Economic Commission for Europe**Inland Transport Committee****Working Party on the Transport of Perishable Foodstuffs****Seventy-ninth session**

ATP Handbook**Amendments to paragraph 6 (c) (iii) of Annex 1, Appendix 1
of the ATP Handbook: Rules to be observed for the
installation of mounted units, units with deflectors, under-
frame units or units that can be offset****Transmitted by the Government of France****Revision****Introduction**

Case No. 1: Standard production vans with integrated insulation and unit partially recessed in the roof:

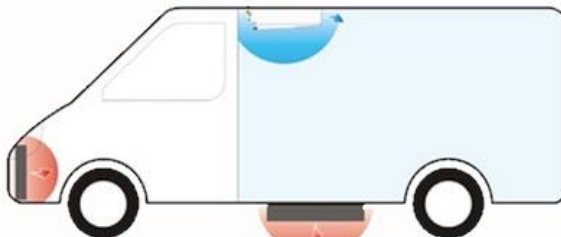
- A minimum distance should be maintained between the walls of the recessed drip basin and the air inlet of the condenser;
- A maximum depth of the drip basin should be ensured. The drip basin should not be deeper than the maximum height of the unit's condenser.
